**FINAL REPORT**

December 17, 2021

# **Review and Evaluation of Rhudes Creek Solar, LLC Siting Assessment Report**

**Prepared by**

**Figure C-3.**  
**Map of Construction Phases for Rhudes Creek Solar Project**

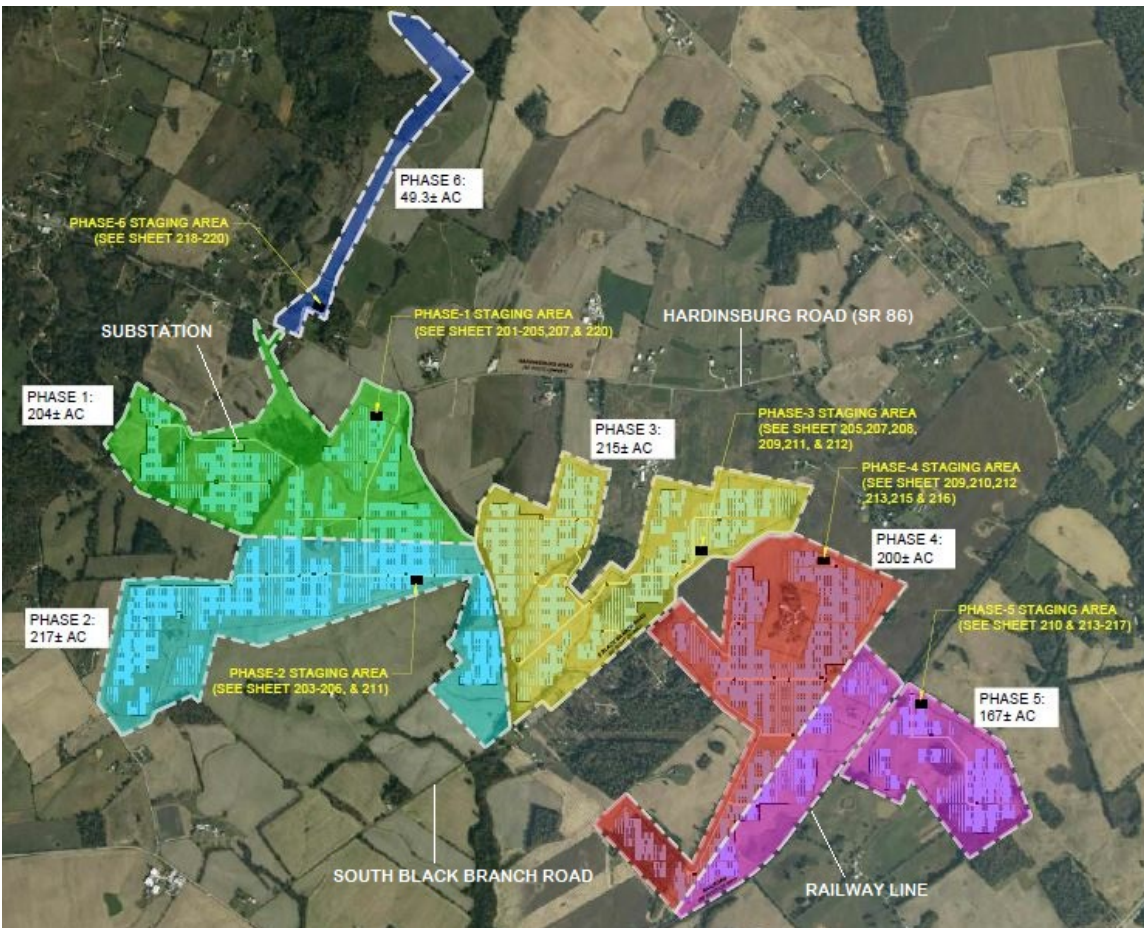
The proposed project's construction phases would progress from west to east within the project boundary, beginning with Phase 1 (shown in green), which includes the facility substation. The sixth and final phase of construction would be the gen-tie transmission line and switchyard on the north side of the project (shown in dark blue).

**Figure C-5.**  
**Sample Landscape Vegetative Screening Plan for Rhudes Creek Solar Project**

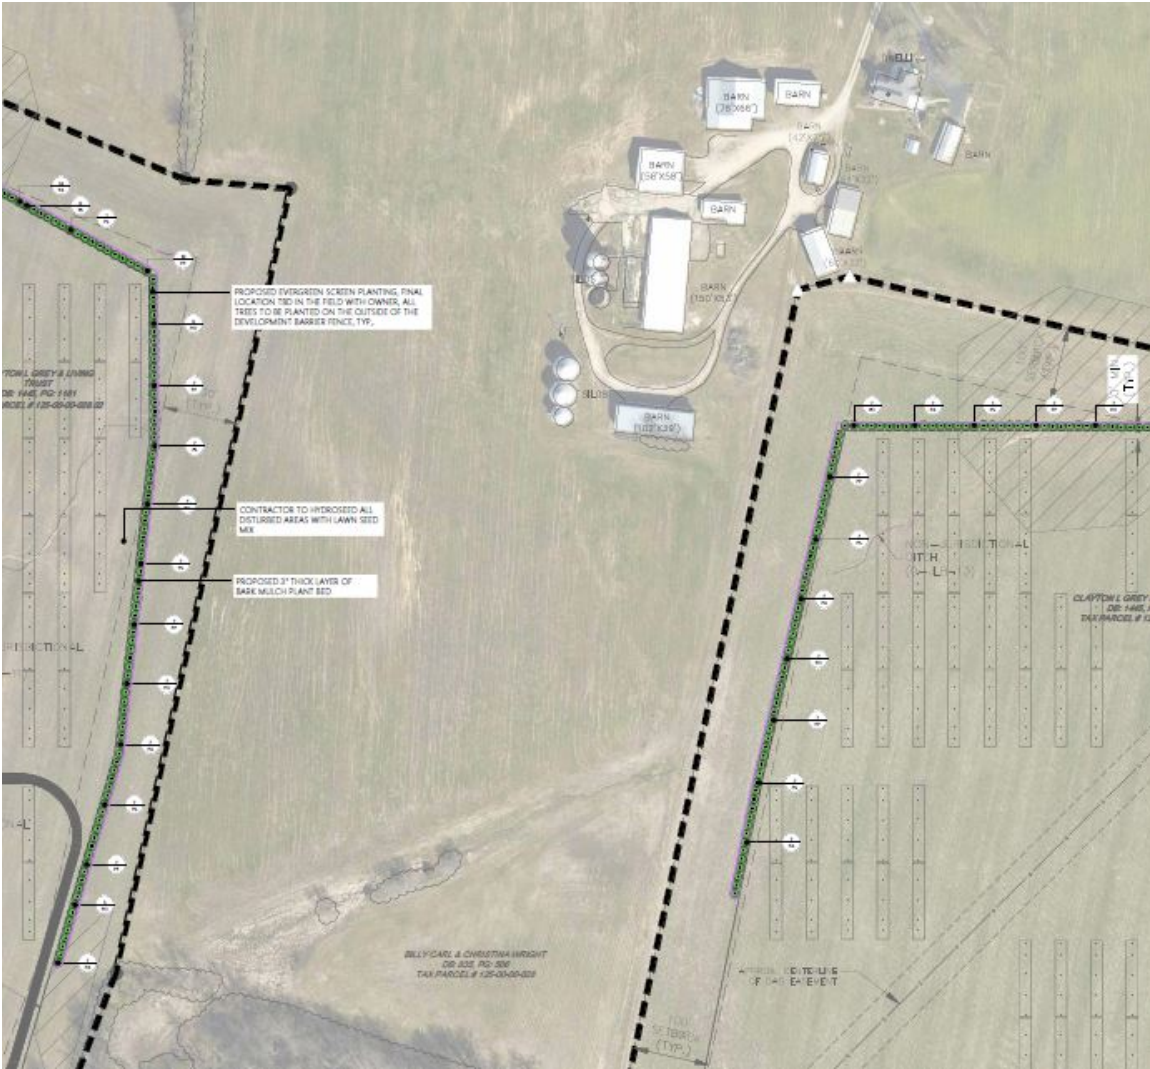
The landscaping plans included in SAR Attachment 1 (Site Development Plan) provide specific details on the approximate locations and lengths of the proposed vegetative screens of evergreen trees. Figure C-5 shows proposed vegetative screens at boundaries where the project footprint is near a dwelling. Vegetative screening is marked in dark green.

6. Rhudes Creek Solar should execute the screening plan proposed in their application and SAR and make sure the proposed new vegetative buffers are successfully established and develop as expected over time. Plantings should reach eight feet high within four years. Should the vegetation used as buffers die over time, Rhudes Creek Solar should replace them to maintain the visual buffer.

**C-6.**  
**Cross-Section of the Cone of Vision for a Driver Traveling on South Black Branch Road**

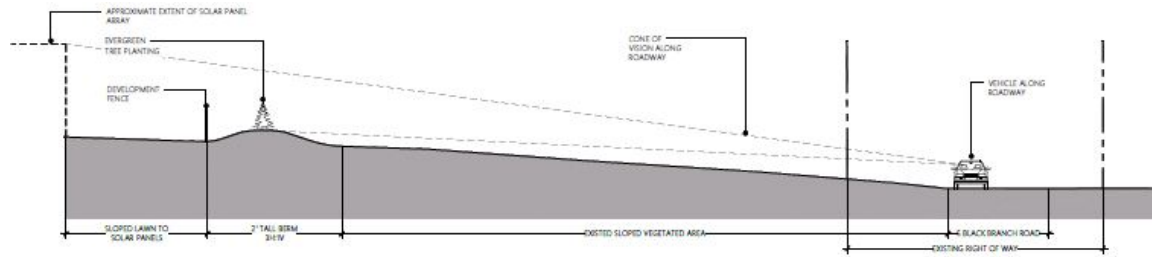
Figure C-6 depicts a vehicle traveling along South Black Branch Road, showing the layout of the berm vegetative screen and resulting cone of vision that obscures a direct view of the solar arrays.
